BOARD MEETING DATE: December 4, 2015

PROPOSAL: Proposed Amendments to NOx RECLAIM Program (Regulation XX)

SYNOPSIS: The proposed amended Regulation XX will implement Control Measure CMB-01 of the 2012 Air Quality Management Plan and make further reductions of NOx from RECLAIM facilities. The proposed amendments implement NOx Best Available Retrofit Control (BARCT) for various equipment by establishing RECLAIM Trading Credit (RTC) reduction targets and RTC adjustment factors for year 2016 and beyond. The proposed amendments include a Regional New Source Review Holding Account for electricity generating facilities, a delay in relative accuracy testing audit due dates for specified situations, both a quarterly maximum (quicker response) and changed and new minimum price triggers for RECLAIM program review, and other administrative changes. In addition, an off-ramp for electricity generating facilities at BACT or BARCT is proposed as well as provisions that would remove RTCs from the RECLAIM Program for equipment and facilities that have shutdown. At full implementation the proposed amendments will reduce NOx RTCs by 14 tons per day by December 2022.

Figure B. 3 – Revised PWVs of Control Devices for Refinery Boilers/Heaters (March 2015)

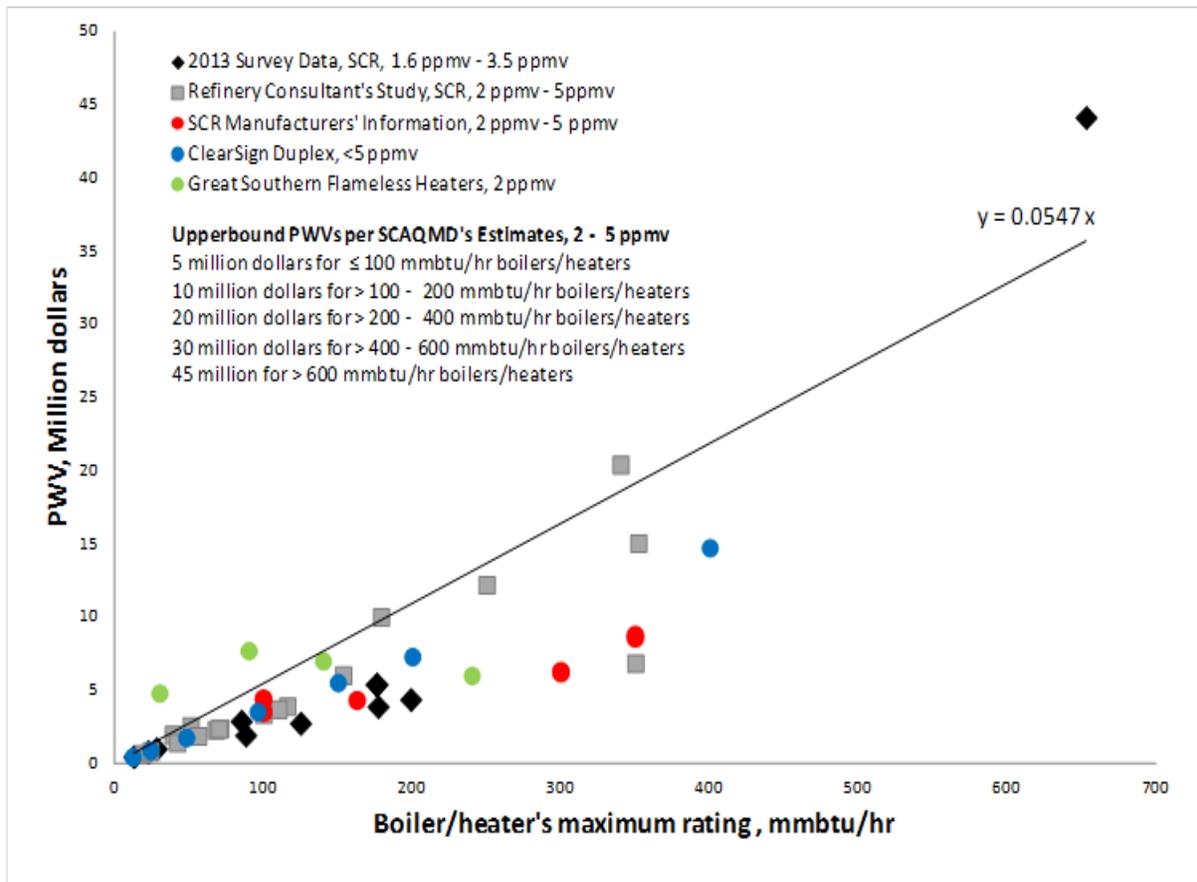
1. The refineries requested staff to use a factor of 4 (not of 3, which was a combination of the 1.86 factor recommended in the EPA OAQPS Guidelines and 50% added contingency) to estimate the installed costs from the equipment costs provided by the manufacturers. Staff agreed with this recommendation and revised the calculated PWVs based on the manufacturers’ information. Revised PWVs are included in Figure B.3 above.
